**Historic Architectural Review Commission
Staff Report for Item 2**

Application Number: H16-03-0033

Address: #724 Caroline Street

Demolition of rear wall end one-story rear addition. Demolition of cistern, greenhouse, and overhead roof structure at the rear yard. Second Reading.

SITE DEMOLITION PLAN

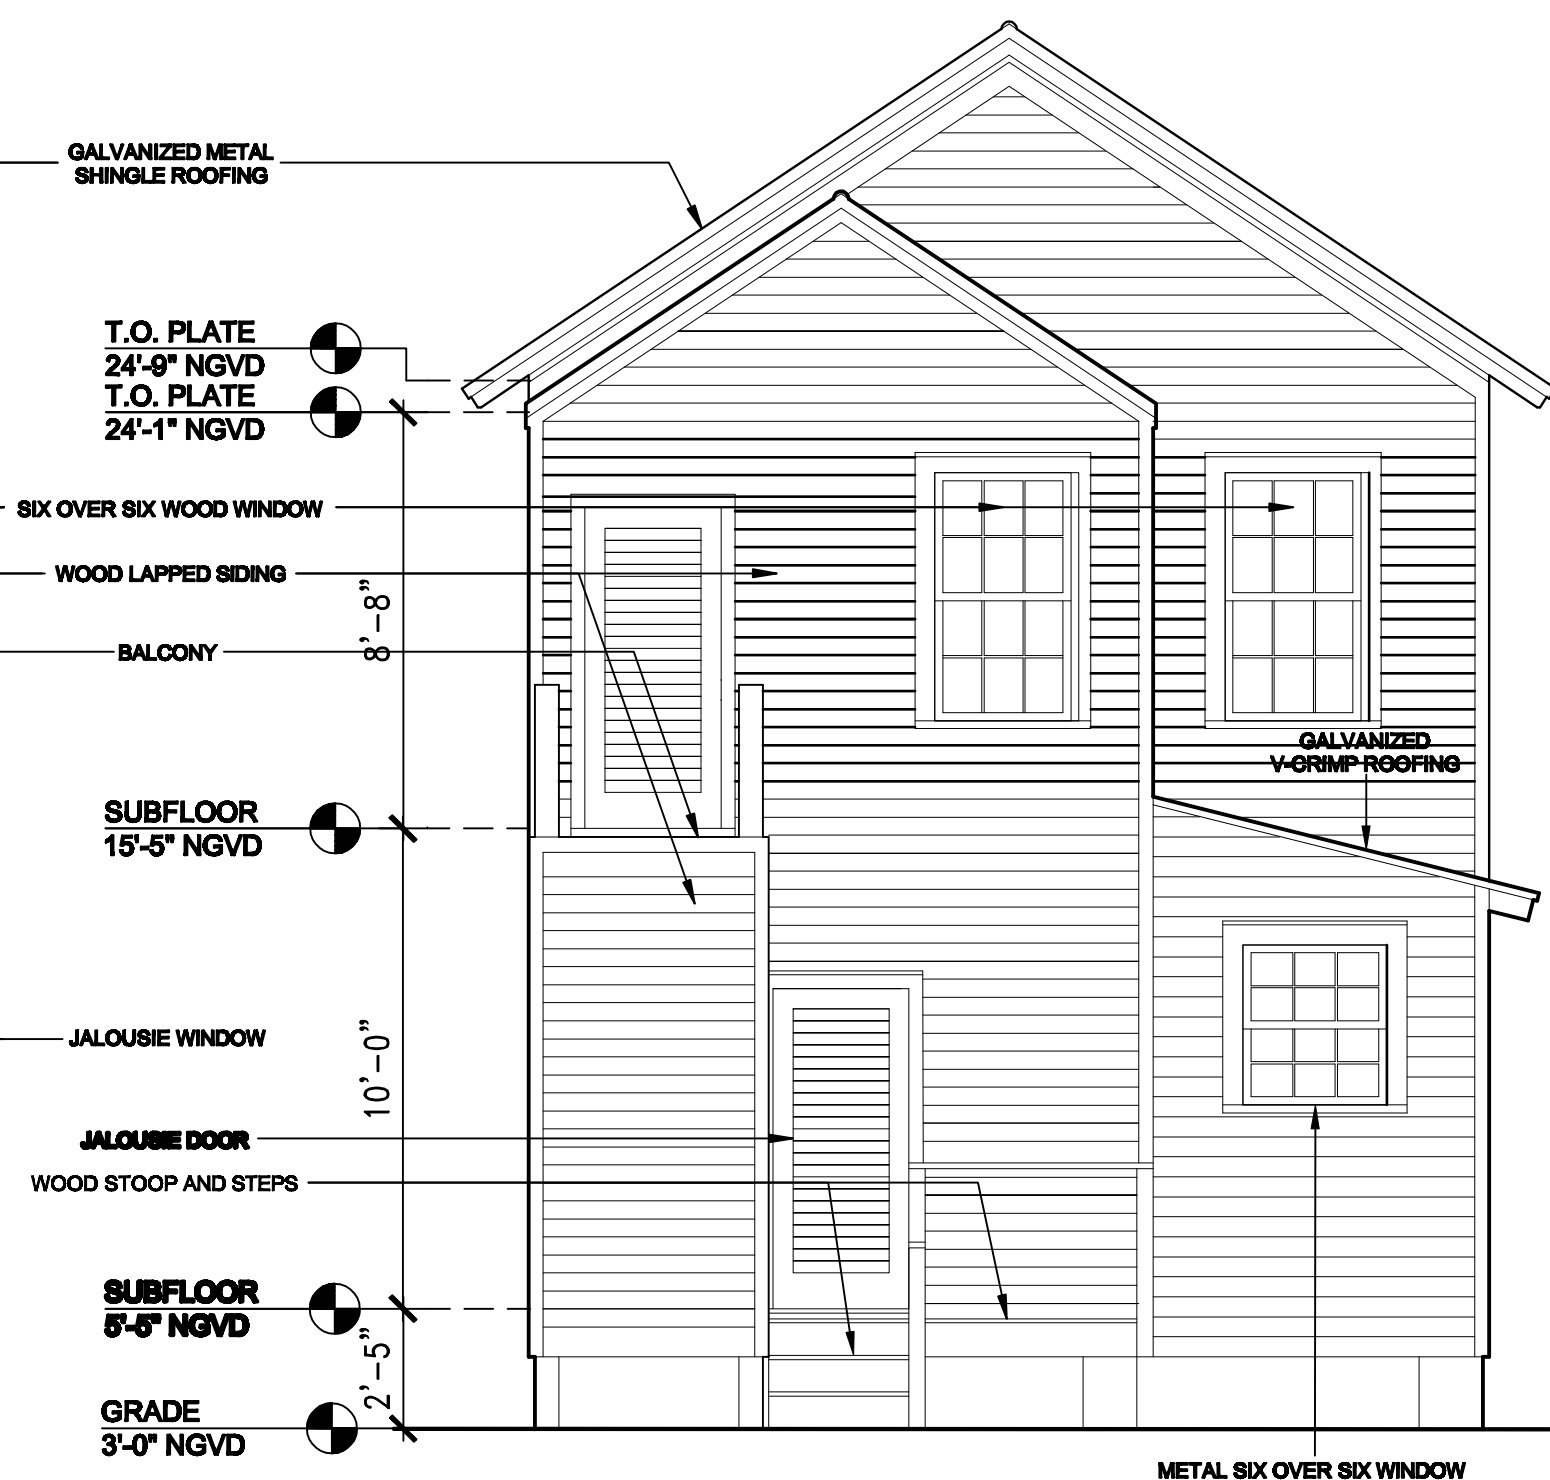
The plan includes the demolition of several non-historic elements found in the rear of the site. At the time of this report the greenhouse, which was a non-historic structure made with wood lattice, has been already removed.

It is important to mention that staff has studied available information regarding the above ground cistern - “concrete shed” on the survey, that is proposed to be demolished. The Sanborn maps from 1899 through 1948, depict a cistern on the rear yard of the property. The 1948 color-coded Sanborn map depicts the cistern in blue color, which means that the structure is in concrete or masonry. The 1962 Sanborn map does not portrait any accessory structure on the site. The separation between the cistern and the historic rear footprint of the house in the Sanborn maps versus the location of the “concrete shed” in the survey are very similar. In addition, the construction materials are definitely more than 50 years old. It is evident that the height of the structure was altered through time and that the old mango tree roots have done some damage to the structure. For those reasons, staff will consider and review the request for this structure to be demolished as a historic resource.

The structure in question is not irrevocable compromised by extreme deterioration. There are some cracks due to the mango tree root system. The cistern has a wooden gable roof with metal v-crimp.

Staff opines that the structure has no distinctive characteristics of a type or method of construction. The structure was built for a utilitarian purpose and does not possess any architectural features. The structure has been altered through time.

In conclusion, it is staff's opinion that the Commission can consider the request for demolition proposed in the plans as it complies with the criteria for demolition stated under the Land Development Regulations. If approved this will be the last reading.
